9490 N. Melinda Drive

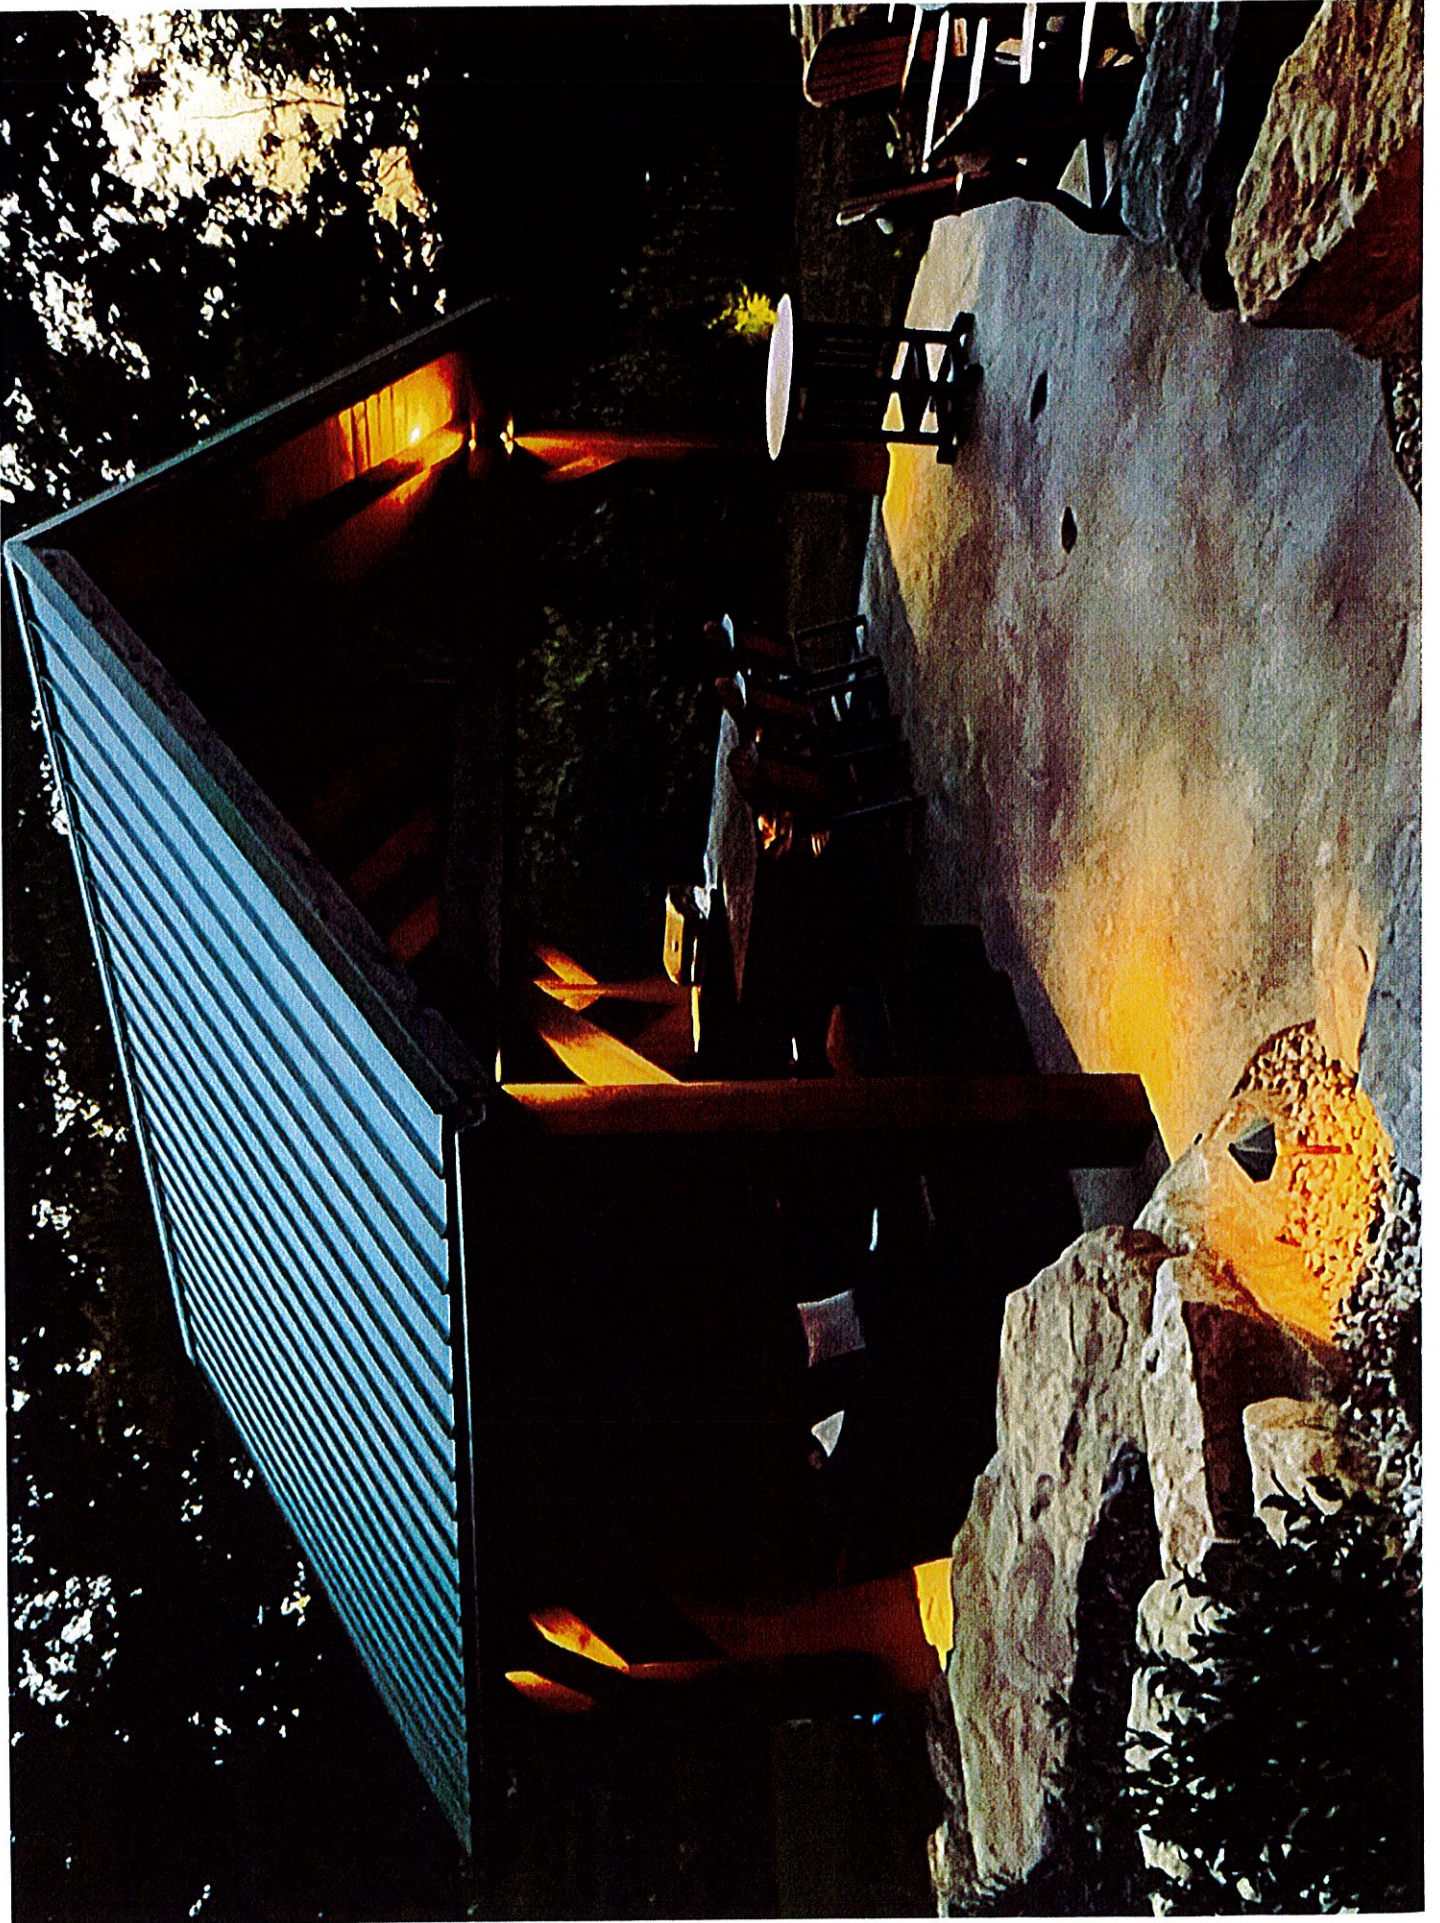
Proposed 320 sq.ft. (16' x 20') detached accessory structure (pavilion).

The maximum allowable square footage for a detached accessory structure when an attached garage exists is 200 sq.ft.

A 120 sq.ft. variance is requested.

6044 Long Street

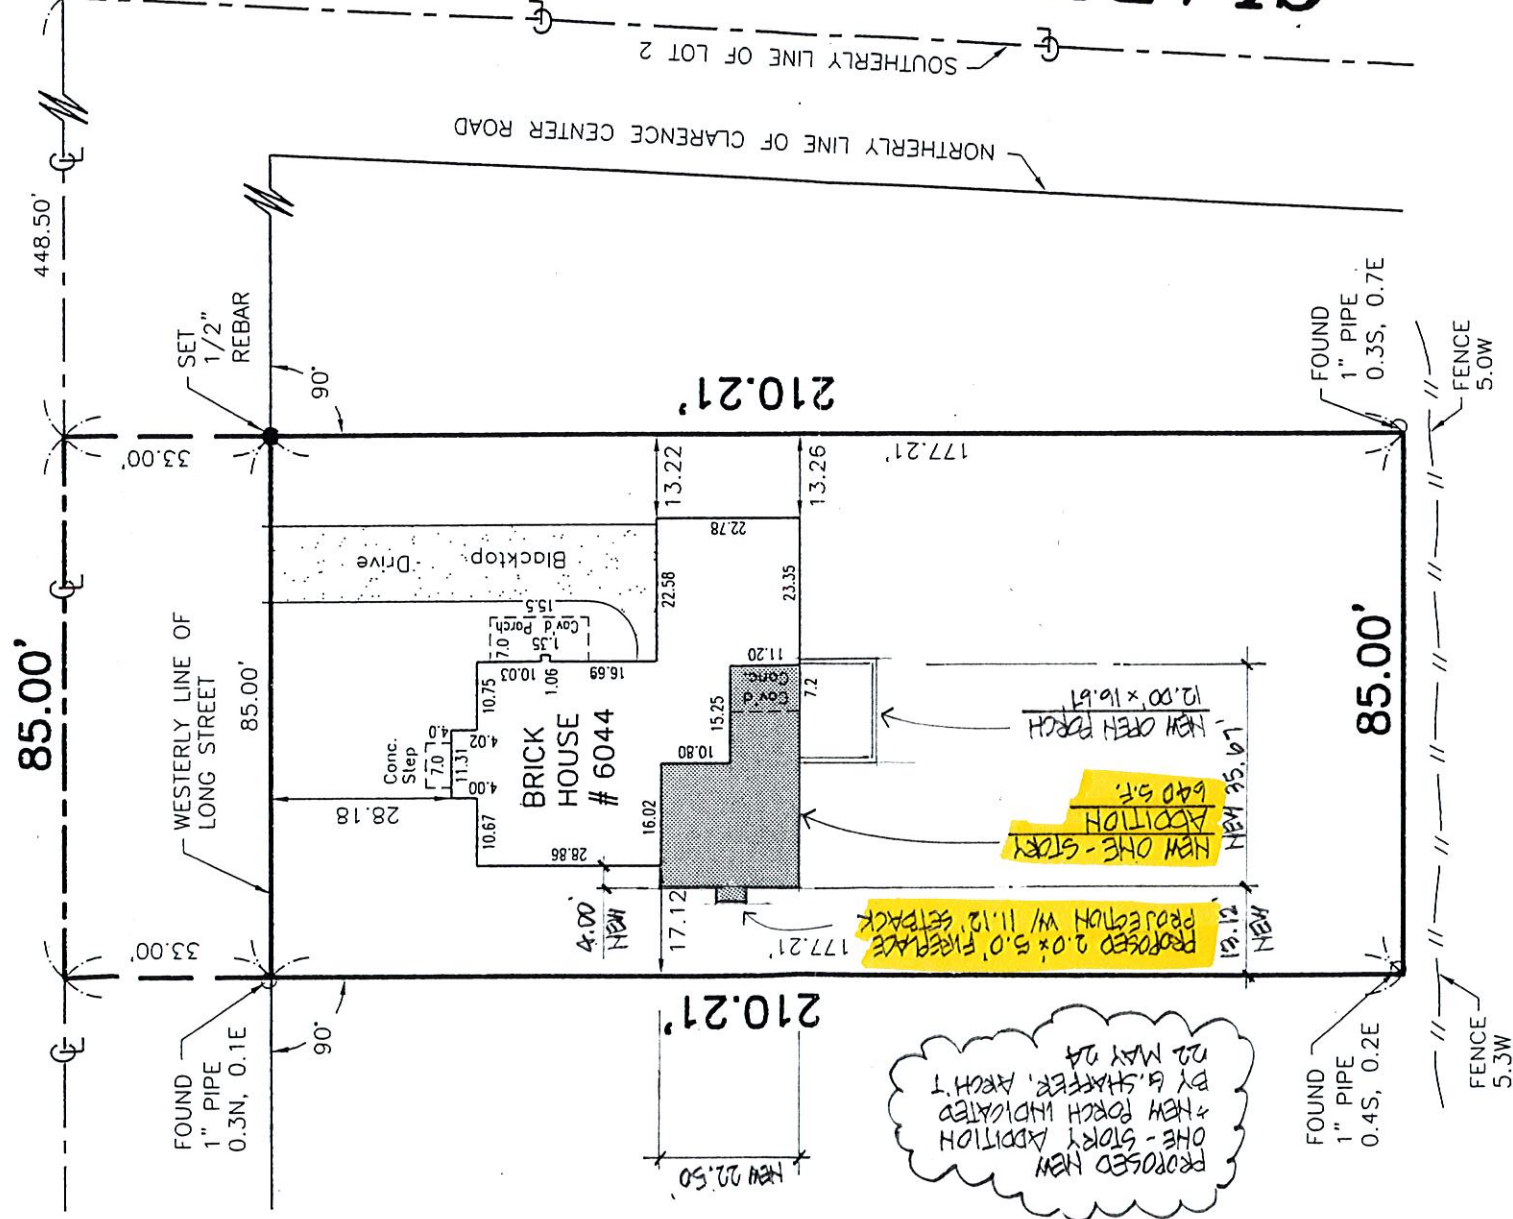
Proposed addition to the principal structure, resulting in a total lot coverage of 15.4%.

The maximum allowable lot coverage is 13% for a two-story structure.

A 2.4% variance is requested.

4181 Shimerville Road

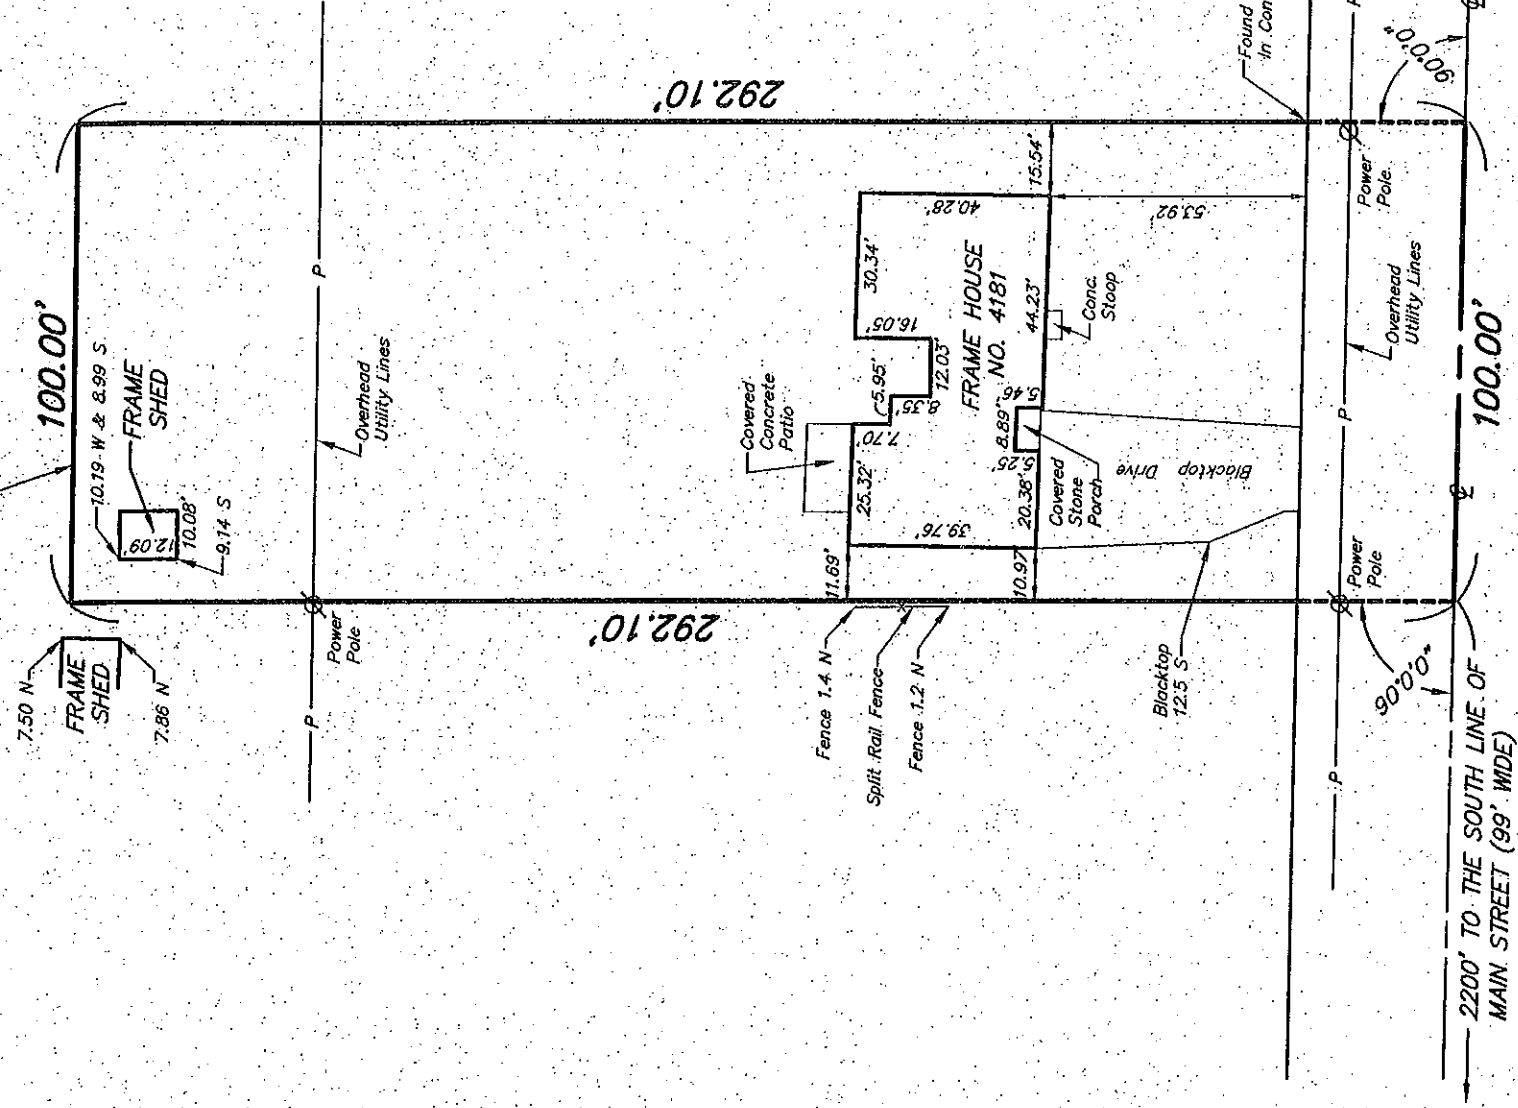
Proposed 342 sq.ft. (28'6" x 12') detached accessory structure (shed).

The maximum allowable square footage for a detached accessory structure when an attached garage exists is 200 sq.ft.

A 142 sq.ft. variance is requested.

8427 Lakewood Court

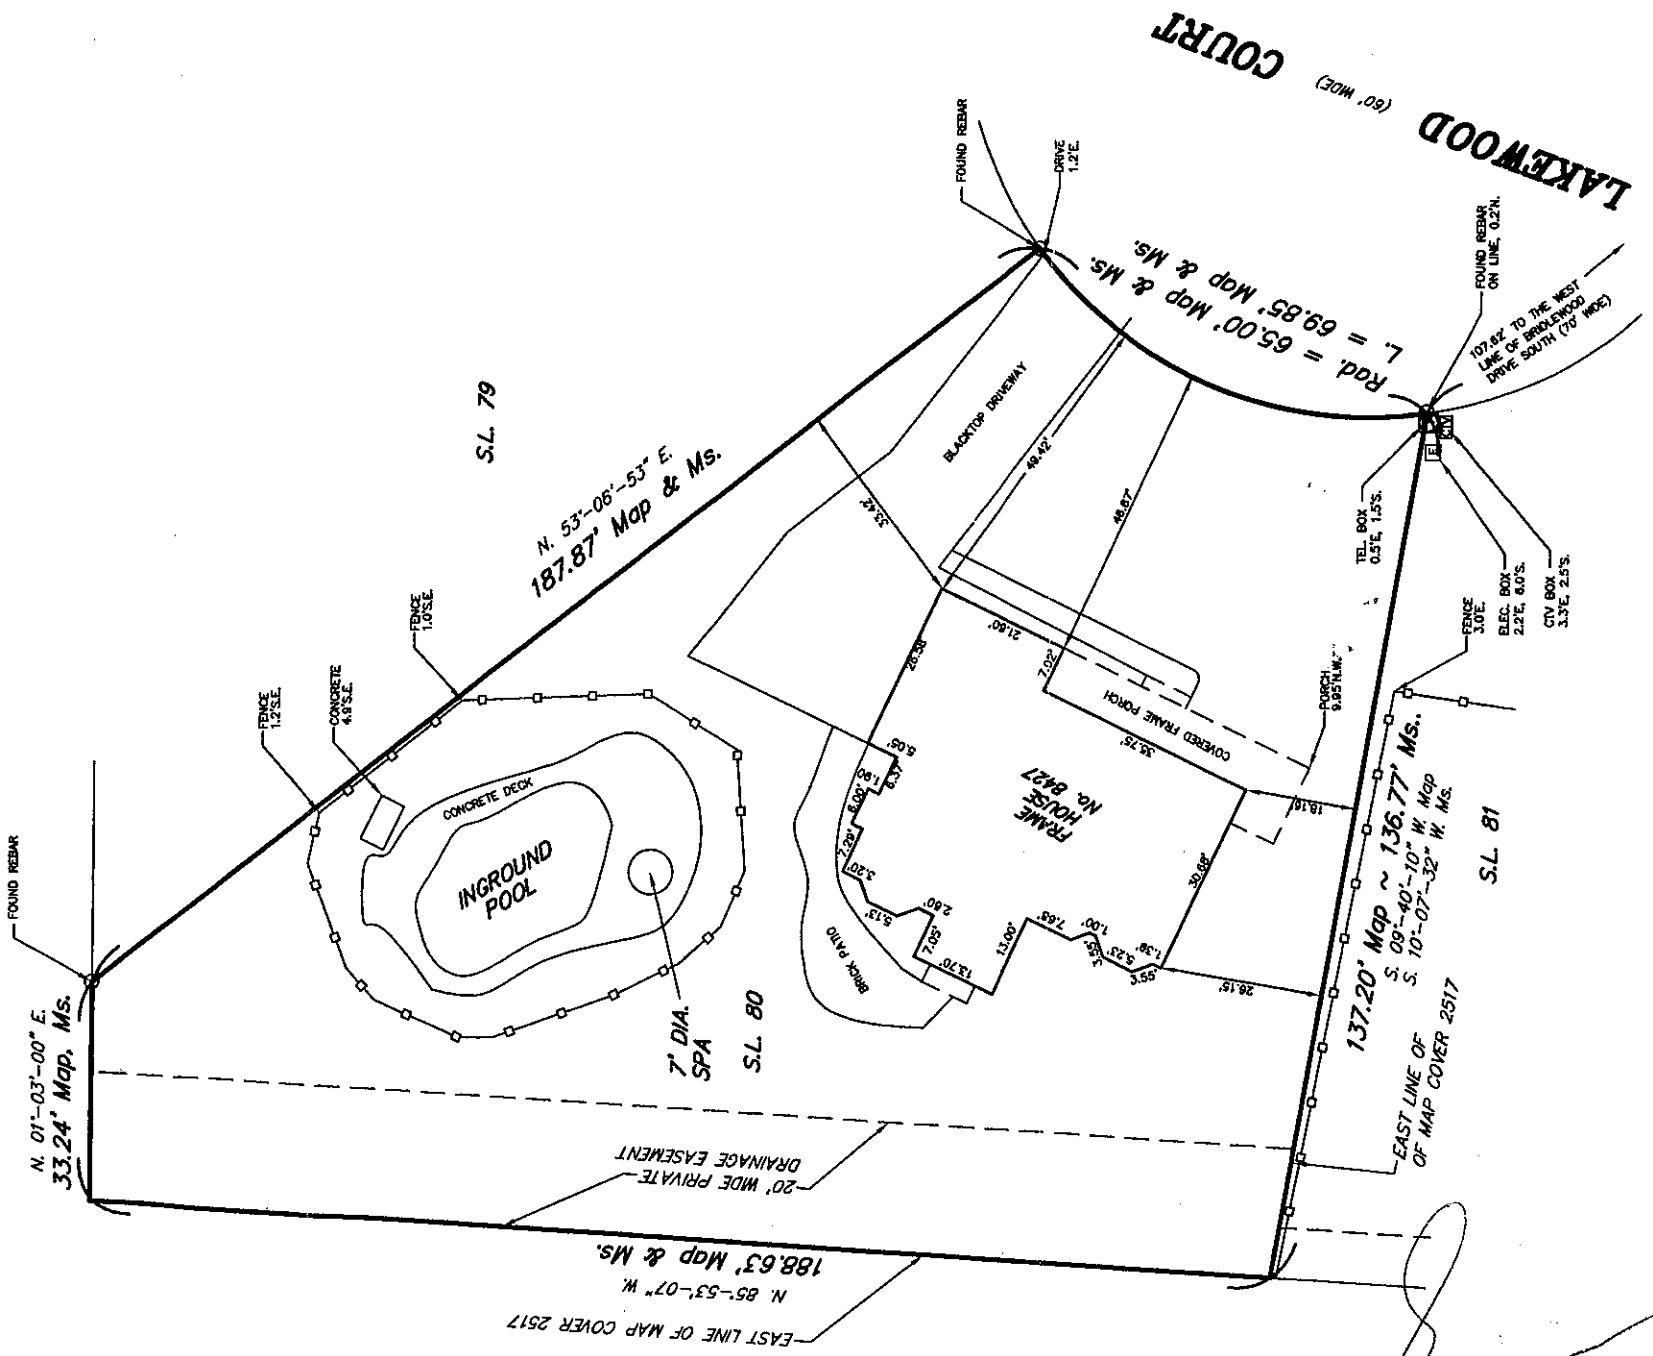
Proposed 464 sq.ft. (29' x 16') detached accessory structure (pool house).

The maximum allowable square footage for a detached accessory structure when an attached garage exists is 200 sq.ft.

A 264 sq.ft. variance is requested.

Proposed 6' detached accessory structure side yard setback.

The minimum side yard setback for detached accessory structures in the side yard is 10'.

A 4' variance is requested.
